**REMARKS**

**Amendments to the Drawings**

- 25 Applicants respectfully request acceptance of the Replacement Figures for Figures 3A, 3B, 5B, 9, 13 and 13 presented herewith. An explanation of the changes is provided as follows.

FIG. 3A

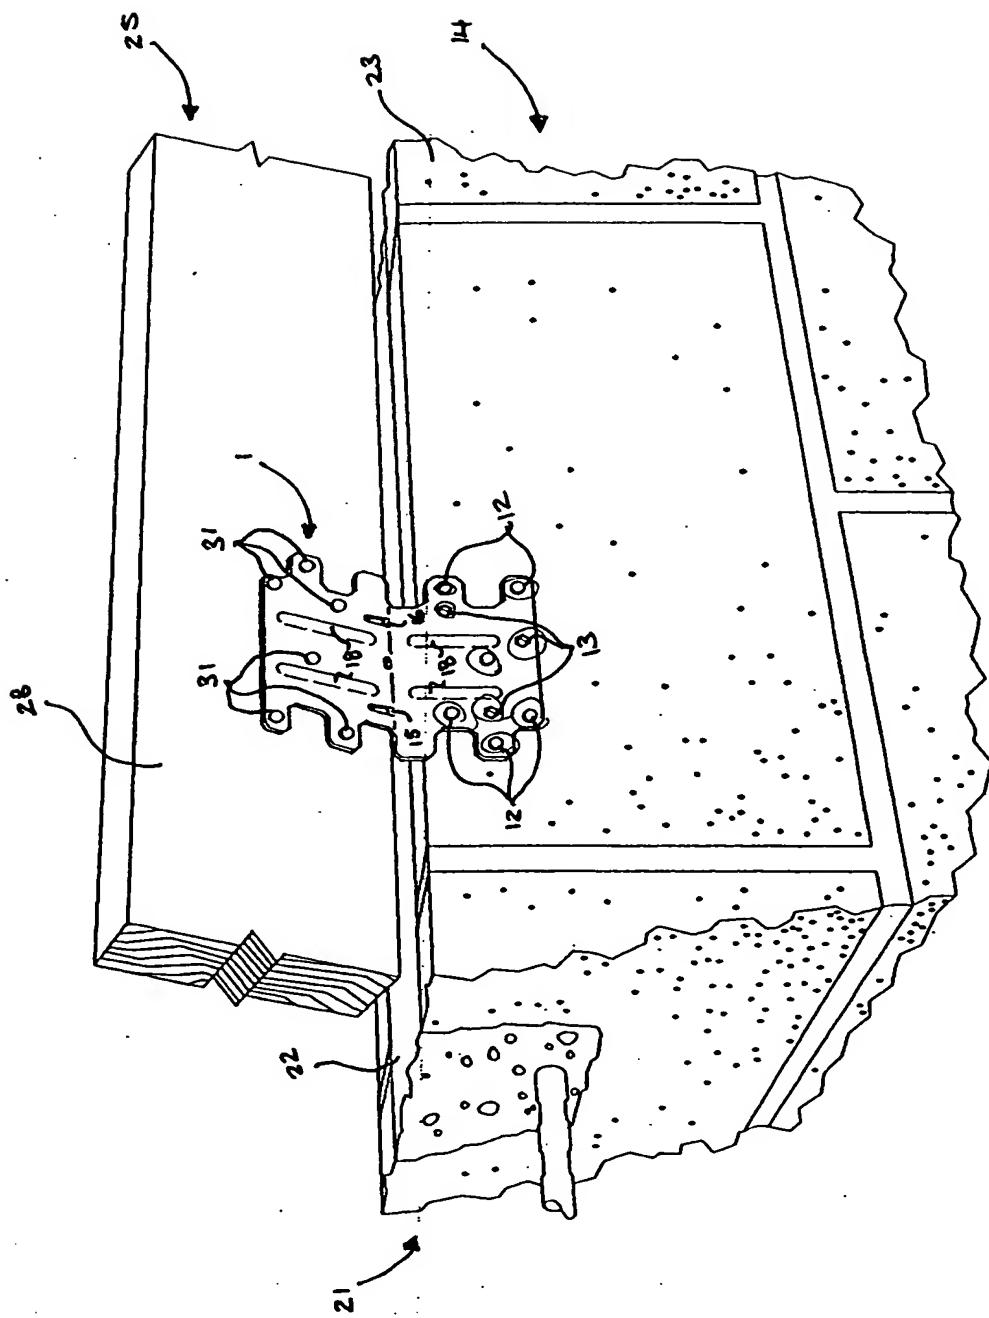
*Figures 3A, 3B, 13A and 13B —*

Applicants respectfully request amendment of Figures 3A, 3B, 13A 30 and 13B, to better represent the fasteners 13 and the fastener openings 12 in three dimensions.

FIG.-3B

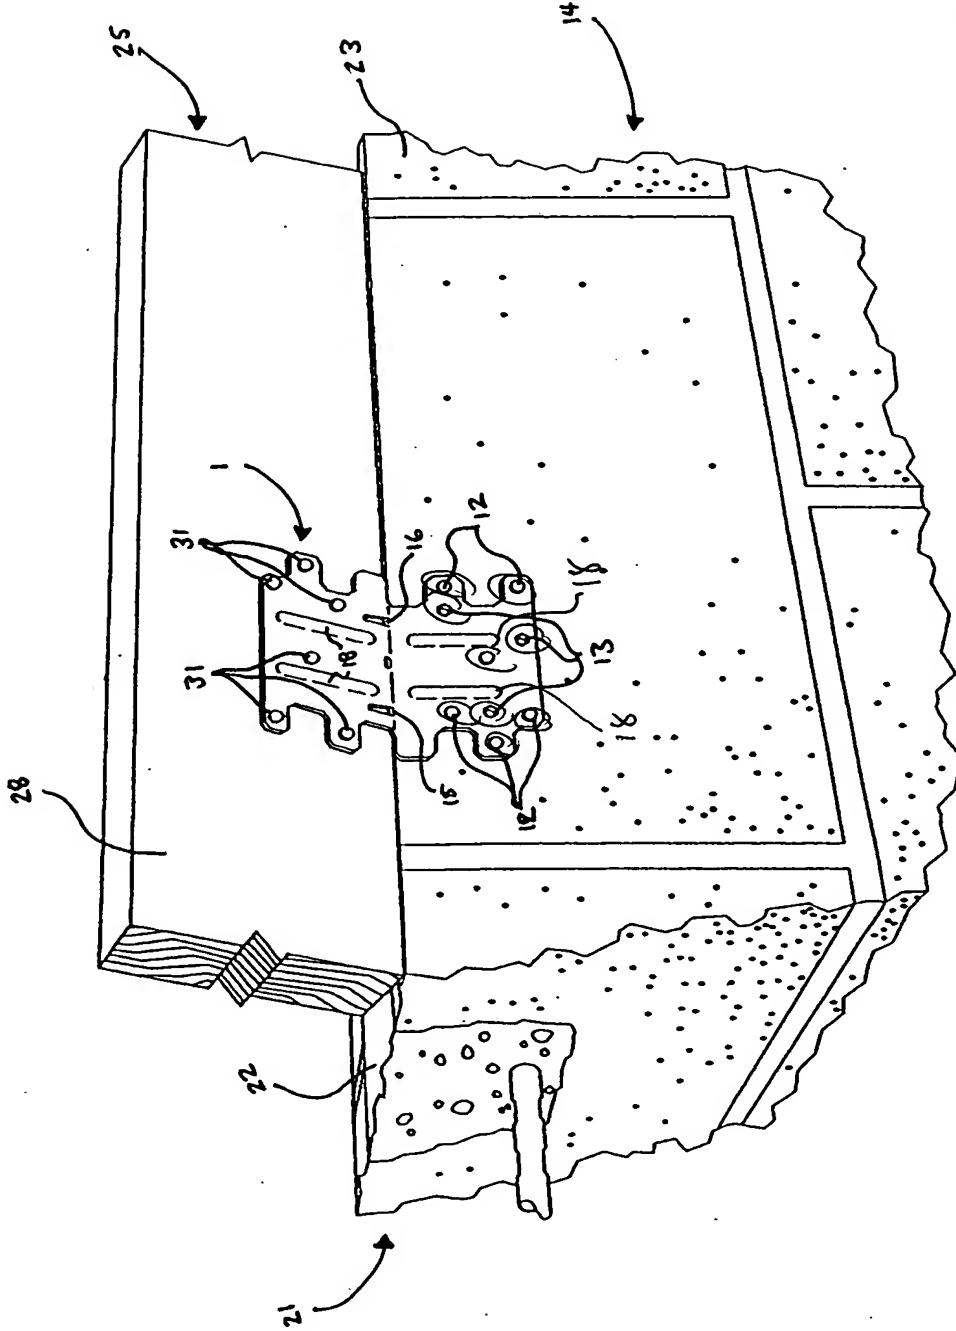
*Figure 3B —*

Applicants respectfully request additional amendment of Figure 3B to add lead lines and reference numerals 18 to indicate the additional 35 embossments on clip 1. These same embossments are shown and labeled in Figure 3A.

FIG.-5B

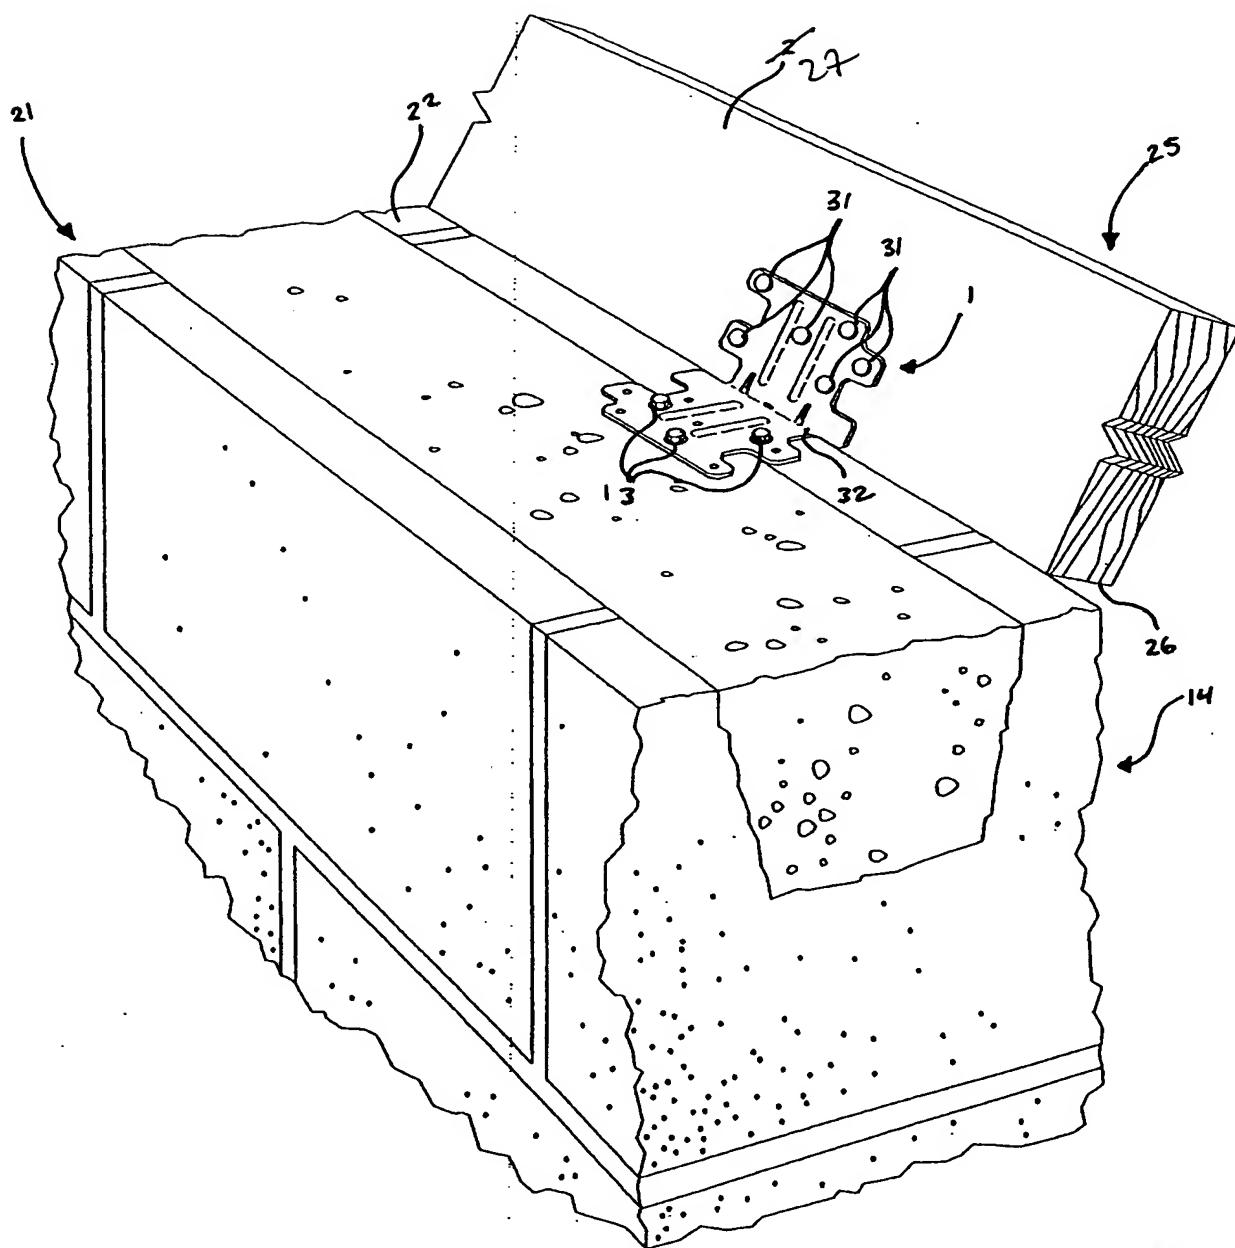
1 *Figure 5B* —

Applicants respectfully request amendment of Figure 5B to change the reference numeral labeling the inner side 27 of the first blocking member 25 from 2 to 27. Figure 1 correctly shows the body 2 of the clip 1 labeled as 2.

11/22

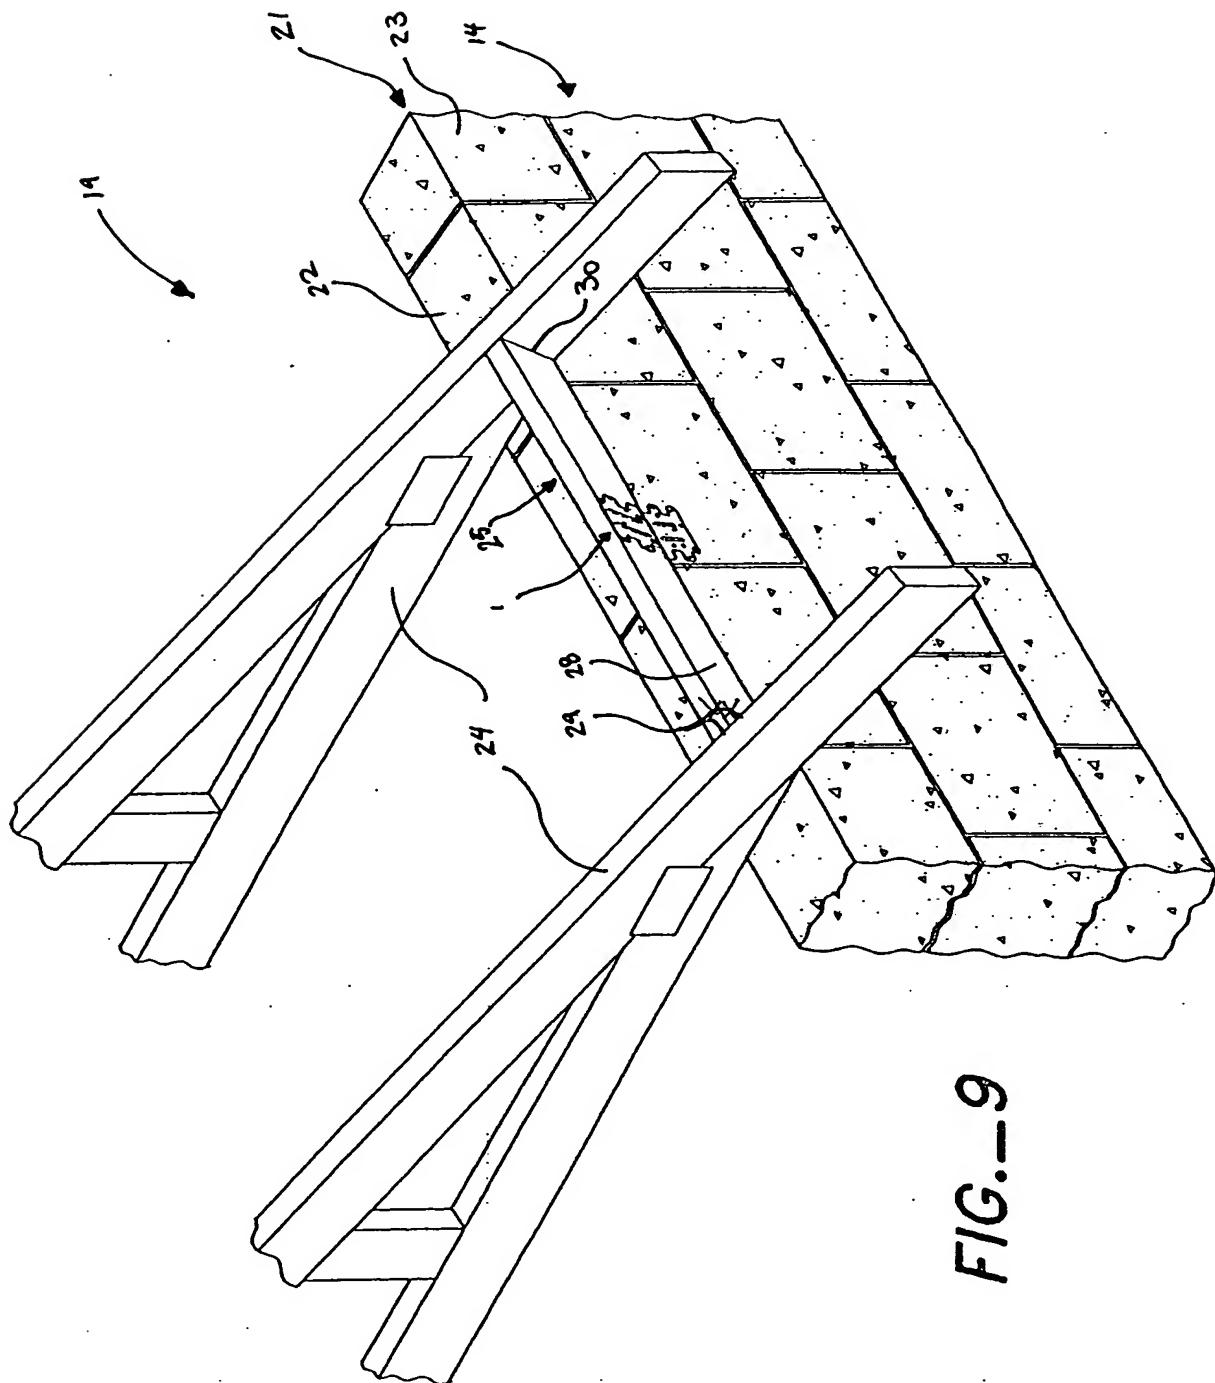
*Figure 9* —

Applicants respectfully request amendment of Figure 9 to change the location to which the lead line indicating the first end 29 of the first blocking 10 member 25 points. This location is shown correctly in Figure 10.
